Architectural Design Statement

For KPH Construction at Killowen, Kenmare, Co.Kerry

5.0 - Response to 32B Consultation Meeting

The following chapter has been prepared in response to the feedback received during the 32B consultation and the subsequent minutes issued by Kerry County Council. It outlines the architectural response to the relevant comments and the resulting refinements to the proposal.

DMURS Extract (Table 3.1)

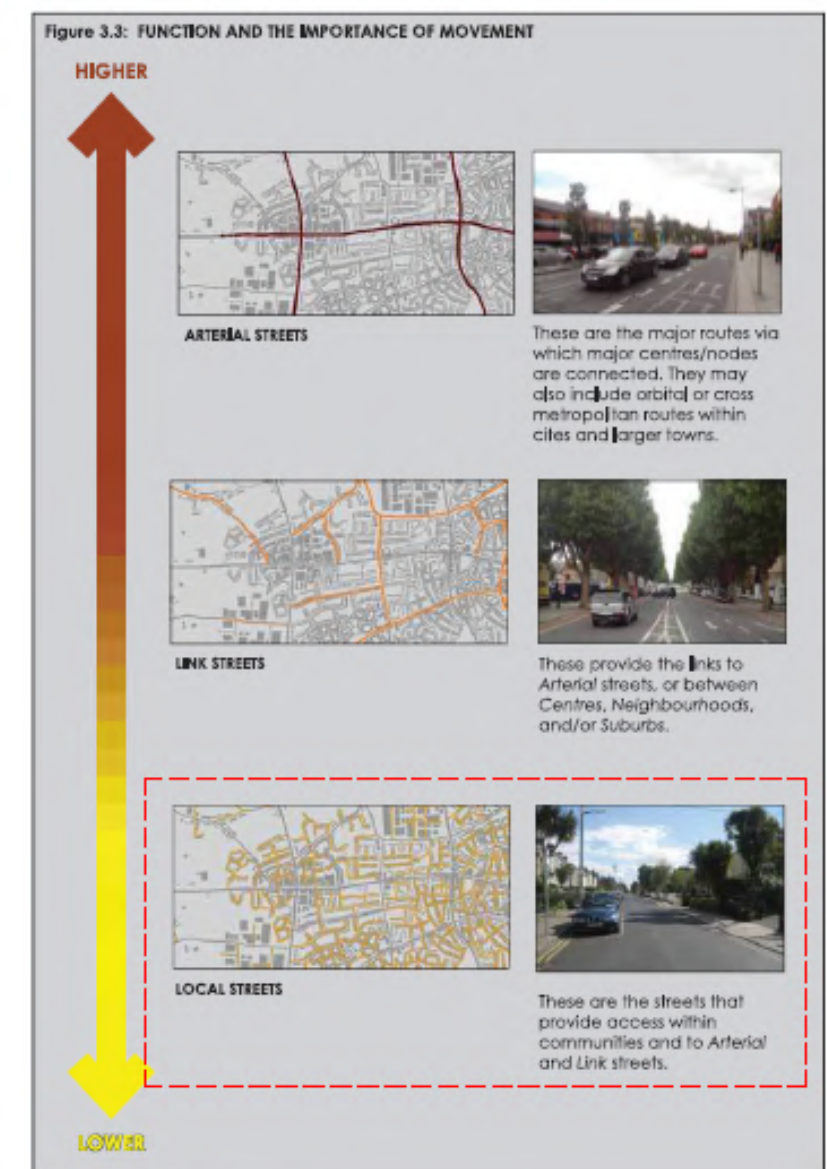
The roadway width should be 6m except for cul-de-sac less than 60m long, where a width of 5.5m should be acceptable. A reduced roadway width may be approved for short spur. cul-de-sac.

The proposed road layout has been developed in accordance with the Design Manual for Urban Roads and Streets (DMURS, 2013), which is the prevailing national guidance for the design of urban streets and takes precedence over legacy standards in urban contexts. In accordance with Table 3.1 and Figure 3.3 Function and Movement of DMURS (2013), the roads within the proposed scheme are classified as Local Streets, which provide access within communities and connections to Arterial and Link Streets. These streets are therefore intended to serve low-speed residential environments with a focus on placemaking, safety, and multi-user accessibility.

Section 4.4.1 of DMURS (2013) states: "The standard carriageway width on Local Streets should be between 5.0-5.5 m (i.e. with lane widths of 2.5-2.75 m). Where additional space on Local Streets is required to accommodate activities such as manoeuvrability for vehicles entering/leaving perpendicular parking spaces, this should be provided within the parking bay and not on the vehicle carriageway" (see Section 4.4.9 On-Street Parking and Loading). This approach is further illustrated in Figure 4.55 Carriageway Widths of DMURS (2013), which demonstrates the appropriate relationship between carriageway width and on-street parking provision. (as illustrated on the following page)

The terminology used within DMURS is explicitly defined in Section 1.3 Application of this Manual, which states that "should" indicates a recommendation, and where designers fail to meet a recommendation, they must clearly document the reasons why and propose mitigation or compensation measures." As such, any departure from the recommended carriageway width must be supported by a clear and evidence-based justification.

The planning authority's reference to Recommendations for Site Development Works for Housing Areas (Department of the Environment, Heritage and Local Government, 1998) is noted; however, this document reflects a more traditional, vehicle-led design approach and must be considered in the context of the more recent DMURS (2013) guidance, which specifically applies to urban streets and promotes a more balanced, place-based design methodology.

In this instance, no justification arises to increase carriageway widths to 6.0 m, as the proposed streets serve a low-speed residential function and do not demonstrate any operational, safety, or vehicle tracking requirement necessitating additional width. Increasing carriageway widths beyond DMURS (2013) recommendations would therefore constitute overdesign relative to the functional requirements of the streets and would conflict with the core principles of DMURS, which seek to avoid unnecessarily wide carriageways that can encourage higher vehicle speeds and detract from pedestrian safety, residential amenity, and overall place quality.

Accordingly, in the absence of any demonstrable justification, it is not considered appropriate to depart from the DMURS (2013) recommended carriageway widths.

Standard Road Widths Diagram

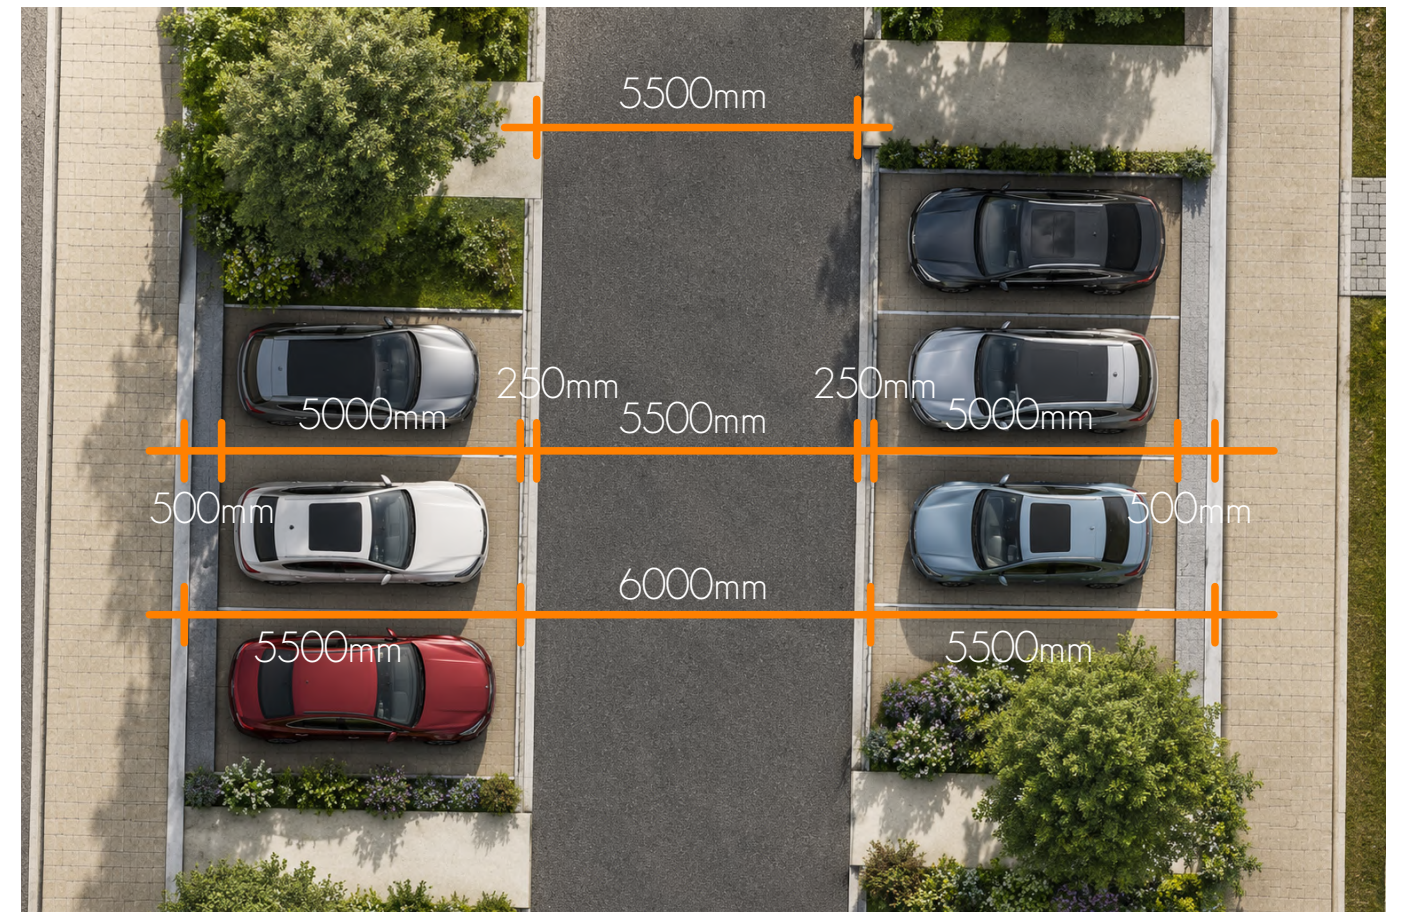
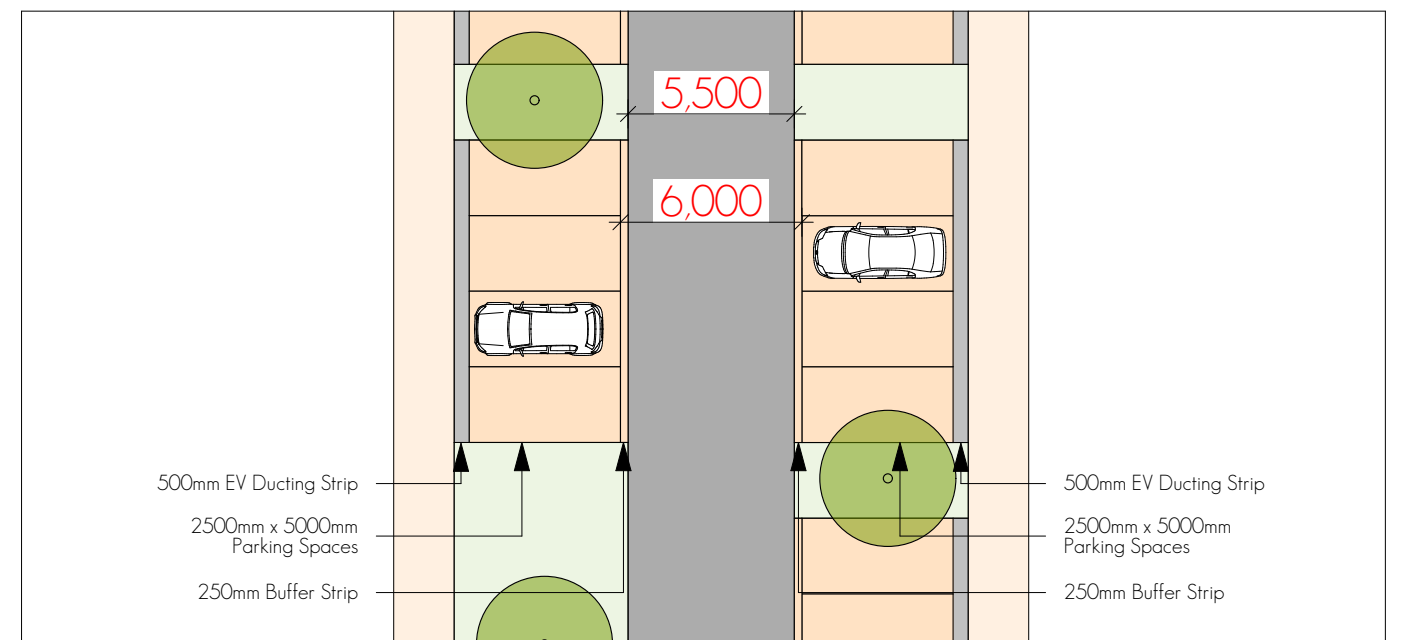
The roadway width should be 6m except for cul-de-sac less than 60m long, where a width of 5.5m should be acceptable. A reduced roadway width may be approved for short spur cul-de-sac.

The proposed internal road layout has been designed in accordance with the principles of Design Manual for Urban Roads and Streets (DMURS), with particular regard to creating a low-speed, pedestrian-friendly environment while maintaining safe vehicular manoeuvrability.

In locations where perpendicular parking is provided, the carriageway comprises a 5.5m wide vehicular running lane together with a 250mm buffer strip between the carriageway and the parking bays on either side. Collectively, this provides an effective manoeuvring width of 6.0m, facilitating the safe and efficient movement of vehicles entering and exiting the parking spaces without encroaching on opposing traffic.

The inclusion of the buffer strips provides the necessary clearance adjacent to the parking bays, ensuring that the effective operational width satisfies the manoeuvring requirements associated with perpendicular parking while also reflecting the DMURS objective of avoiding unnecessarily wide carriageways that could encourage excessive vehicle speeds. The proposed road layout therefore provides an appropriate balance between vehicular functionality, parking accessibility, and a high-quality urban streetscape.

241088-MA-SW-XX-DR-A-10016-P01-Proposed Site Layout Plan (Roads and Paths)

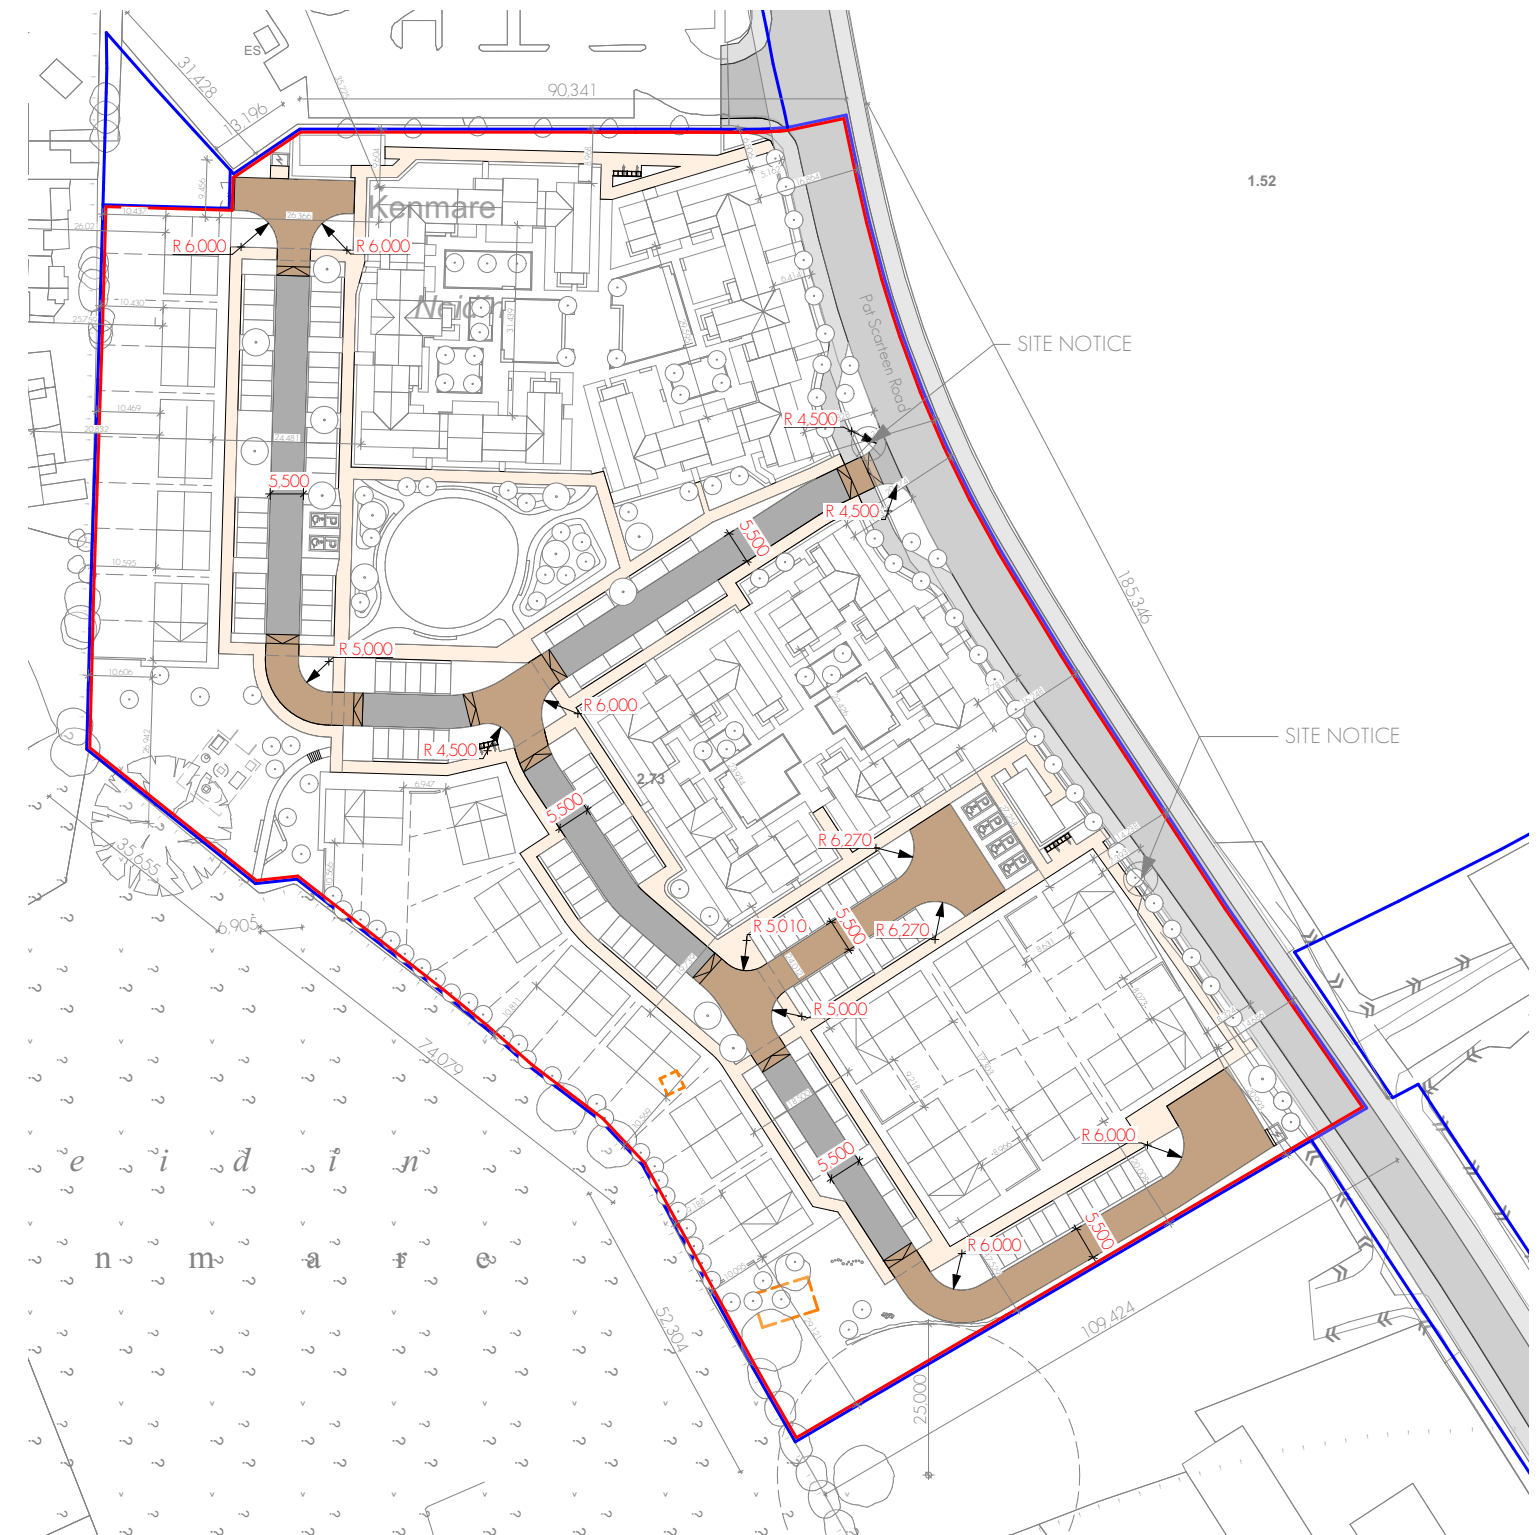
Proposed Entrance radii = 4.3m - according to DMURS large vehicles will cross the centre line of the road when entering the new Development.

Proposed 12-metre-wide hammer head - Bin Lorry, Fire Vehicle or Larger commercial vehicle will struggle to turn safely.

DMURS does not deal/assess regards dead ends / cul de sac. Site Development document is still in use and not superseded.

The proposed turning heads and turning radii have been revised to address this issue. The accompanying drawings illustrate the proposed internal road layout, including the geometry of the carriageways, junctions and turning radii.

The road network has been designed in accordance with the principles and standards set out in the Design Manual for Urban Roads and Streets (DMURS) and has been developed to accommodate the operational requirements of emergency and service vehicles.

The proposed junction radii, carriageway widths and turning arrangements have been designed to facilitate the safe manoeuvring of fire appliances, refuse collection vehicles and other service vehicles throughout the development. The accompanying drawings demonstrate that the proposed road layout can accommodate these vehicles and satisfactorily addresses the queries raised in relation to turning radii, entrance geometry and vehicle access.

Accordingly, it is considered that the proposed development provides a safe and functional road network that complies with the relevant guidance contained within DMURS and is suitable for the intended operational requirements of the development.

Please refer to the Autotrack drawings included within the engineering drawing pack for further information.

241088-MA-SW-XX-DR-A-10008-P03-Proposed Site Layout Plan (Parking Strategy)

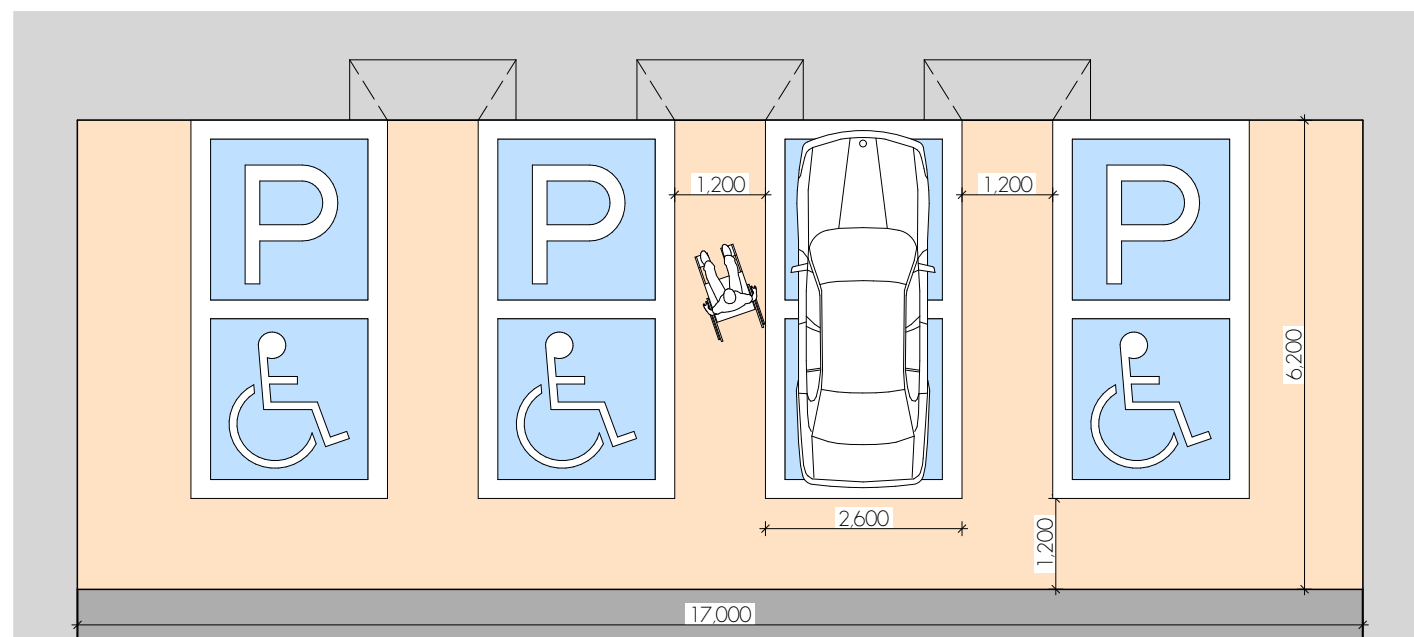
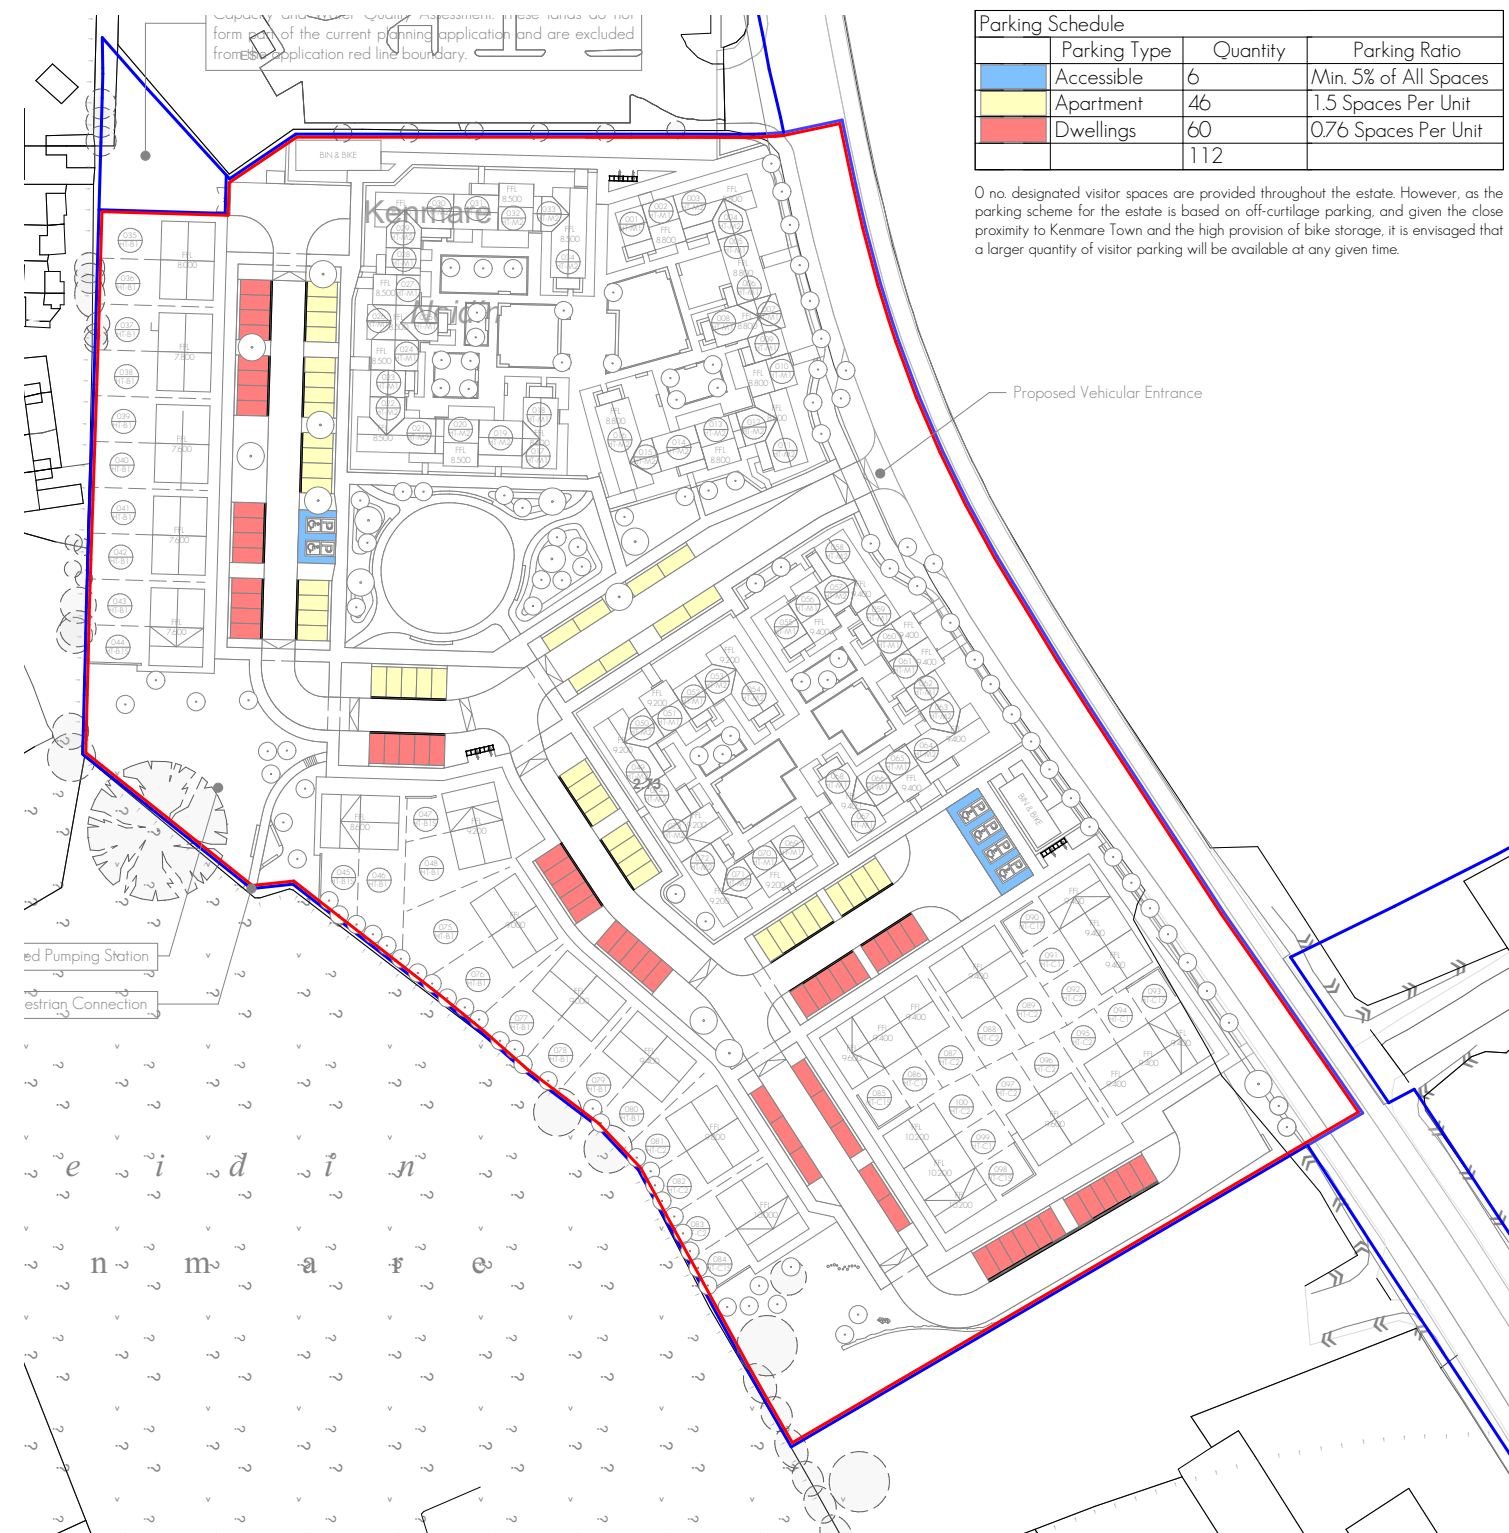
For buildings (including apartment buildings), at least 5% of the total number of spaces should be designated car parking spaces, with a minimum provision of at least one such space.

· LRD Currently - > 5% allocated.

Action - designer ensure designated space dimensions in line with TGD
- M and kerbs are dished correctly.

All accessible parking spaces within the proposed development will be provided in full accordance with the requirements of Part M of the Building Regulations and all associated guidance relating to accessible parking design. This will include the provision of the required parking bay dimensions, access zones, dropped (dished) kerbs, level pedestrian connections, and all other associated design elements necessary to ensure safe and convenient access for persons with disabilities and reduced mobility.

The detailed design of each accessible parking space will fully comply with the prescribed Part M standards, ensuring that the development provides an inclusive and accessible environment for all users.
